**HISTORIC PRESERVATION REVIEW BOARD
STAFF REPORT AND RECOMMENDATION**

Landmark/District:	Capitol Hill Historic District	<input checked="" type="checkbox"/> Agenda
Address:	302 South Carolina Avenue SE	<input type="checkbox"/> Consent
Meeting Date:	October 25, 2018	<input checked="" type="checkbox"/> Concept
Case Number:	18-675	<input checked="" type="checkbox"/> Alteration
		<input type="checkbox"/> New Construction
		<input type="checkbox"/> Demolition
		<input type="checkbox"/> Subdivision

Figure 1: View of rear facade from 3rd Street, SE

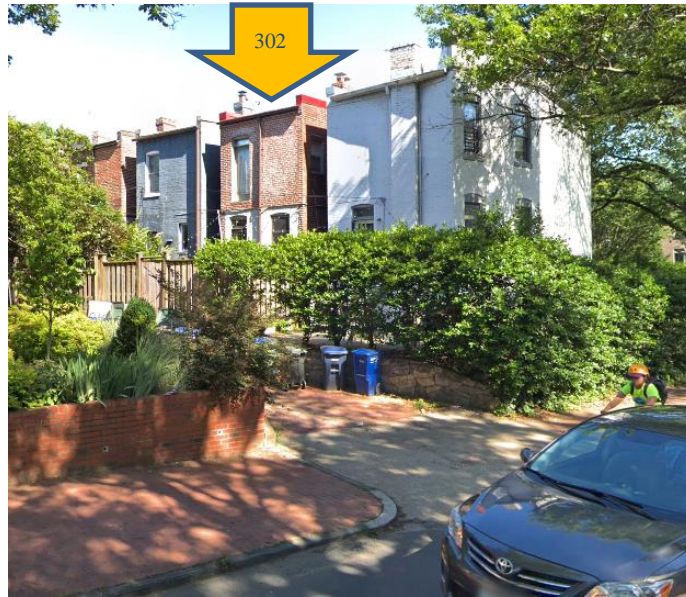
Given the considerations applied by the Board in the review of past cases, and the circumstances of the proposed project and site, it is recommended that the Board not find the concept compatible with the character of the building, row, and historic district. The house is one in a unified row where their rear elevations and roof forms remain unaltered. The rear elevations of this row are not only visible from a street but are set within shallow rear yards that bring the rear elevation unusually close to the alley, sidewalk and street making the visibility of the proposed addition not incidental but prominent. The angle of the block, in which the roof addition would be seen straight-on from vantage points on 3rd Street (as opposed to obliquely) would exacerbate the extent of visibility. Finally, the context of the addition would be on a row of houses of a uniform height undisturbed by roof additions and without taller adjacent buildings that could provide a compatible context for a taller addition.

The proposed rear porches are compatible in form, materials and design. Open wood porches were historically widespread on Capitol Hill, and many remain today. It is not unusual to see sleeping porches from the street and their open form would not alter or obscure the original massing of the house and row.

The HPO recommends that the Board approve the concept of open rear porches as consistent with the purposes of the preservation act and delegate final approval to staff; and that the Board deny the proposed rooftop addition as in consistent with the purposes of the preservation act
